Repair Information VCR04/09

Turbo drive deck

VCR: Paolina, Queen, Apollo

TVCR: Alpha, Beta, Gamma, Delta, Epsilon

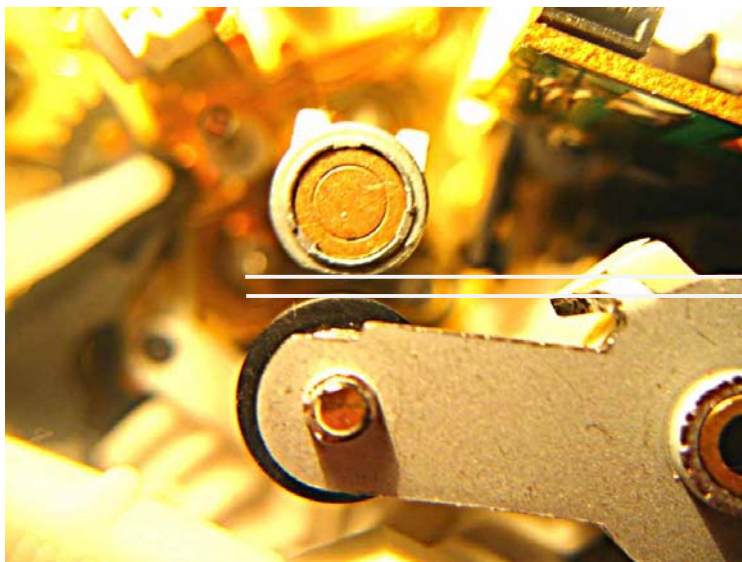
Tape damage during loading and minimal contact force of pressure roller causes tape path problems after having replaced the pressure roller by a new one without an "A" stamped on the metal pate underneath see picture.

- 1.) Check position of pressure roller to capstan motor in 'Eject'

Distance should be:
about 1 to 2 mm

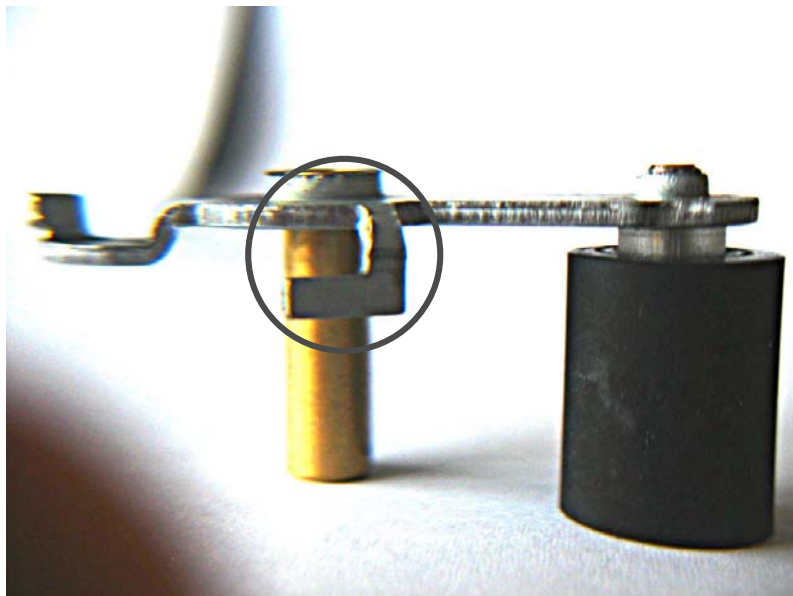
- 2.) If this distance is bigger than 1 to 2 mm the following modification is required
- a.) Original delivered pressure roller

- a.) Pressure roller after modification
